ADDENDUM NO. 4

Invitation to Bid (ITB) 21-101431 On-Call Water And Sewer (Multiyear Contract With 2 Options To Renew) is hereby amended as follows:

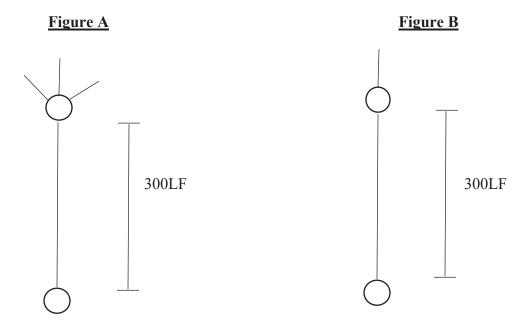
- A. It is **MANDATORY** that the bidder acknowledges Addendum No. 4.
- B. We have received questions pertaining to this Invitation. One question was omitted from Addendum No. 3 and its resulting answer appears below:
 - 1. <u>Question</u>: Bypass pumping pumping is impossible to price given the measurement and payment definition.

One cannot determine the bypast cost of an unknown section of pipe without being able to price out the cost of bypassing the individual segments that feed the particular unknown segment.

Figure A would require 3 separate pumps and potentially thousands of feet of hose.

Figure B would require 1 pump and a few hundred feet of hose.

The cost of these two operations are drastically different, yet the county's current method of pricing would pay the contractor the identical amount for both sections.

There needs to be a way to be compensated for additional pumps needed to bypass a pipe segment that is connected to a manhole which is fed by multiple lines, as represented in FIGURE A.

Please modify the pay item so that contractors can be compensated properly.

Answer: No, the bypass pay items as shown will not be modified, however the following will clarify how the bidder is to price these items. Bidders are to provide unit pricing for bypass pumping in B-1 – Section 2 Small Diameter, Bid Items 176 - 179 assuming one (1) pump setup is required for the bypass operation. Should additional pump setups be required to bypass a pipe segment that is connected to a manhole which is fed by multiple lines, the cost will be negotiated with the Owner.
